Access Compliance Report

Public Rights-of-Way

(Curb Ramps)

Intersection ID: 53389	Main Street: PAISLEY_ABBEY_LN	Cross Street: PAMPLIN_CT	Location: NW
ADA ID: 5AD7E8321084	Ramp Type: BlendTrans1	Initial Pass/Fail: Fail	Overall Compliance: No
		Severity Score: 8.75

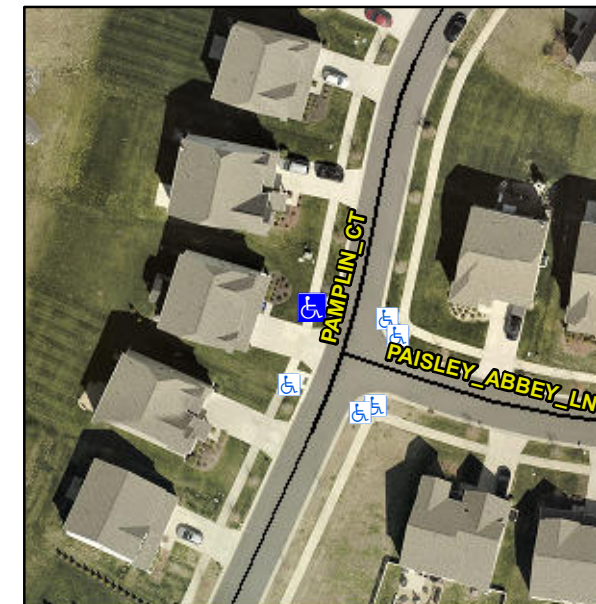
Not Found, R304.5.1

Compliance	Description	Data	Compliance	Description	Data
N/A	Ramp Length (in)	98.0	Yes	BlendTrans Slope (%)	1.8
No	Ramp Width (in)	47.0	Yes	BlendTrans XSlope (%)	1.2
N/A	Flare Type LT	N/A	N/A	Flare Type RT	N/A
N/A	Flare Slope LT (%)	N/A	N/A	Flare Slope RT (%)	N/A
N/A	Flare Traversable LT?	N/A	N/A	Flare Traversable RT?	N/A
N/A	Landing Length (in)	N/A	N/A	DWS Provided?	N/A
N/A	Landing Width (in)	N/A	N/A	DWS Contrast?	N/A
N/A	Landing Slope (%)	N/A	N/A	DWS Length (in)	N/A
N/A	Landing X Slope (%)	N/A	N/A	DWS Full Width?	N/A
N/A	Landing Curb? (Y/N)	N/A	N/A	DWS Offset (in)	N/A
N/A	Shared Landing?	N/A			
N/A	Gutter Ponding?	N/A	N/A	Gutter Slope (%)	N/A
N/A	Gutter Lip Ht (in)	N/A	N/A	Gutter X Slope (%)	N/A
N/A	Painted X Walk1?	No	N/A	Painted X Walk2?	N/A
	X Walk 1 Direction	To SE		X Walk 2 Direction	N/A
	X Walk 1 Width (in)	N/A		X Walk 2 Width (in)	N/A
	X Walk 1 Slope (%)	3.8		X Walk 2 Slope (%)	N/A
	X Walk 1 X Slope (%)	1.9		X Walk 2 X Slope (%)	N/A

N/A	Ramp inside XWalk1?	N/A	N/A	Ramp inside XWalk2?	N/A
	Road Slope (%)	1.9		Clear Space?	N/A
	Road X Slope (%)	3.8	N/A	Clear Space to XWalk (in)	N/A
N/A	Any Obstructions?	N/A	N/A	Storm Grate/Utility Hazard?	N/A
	Obstruction Type			Storm Grate/Utility Type	
		N/A			N/A
			Yes	Surface Condition? (G/P)	Good
			No	Curb Slope (%)	7.4

Remove & Replace Curb Ramp With Two New Directional Ramps or Equivalent.
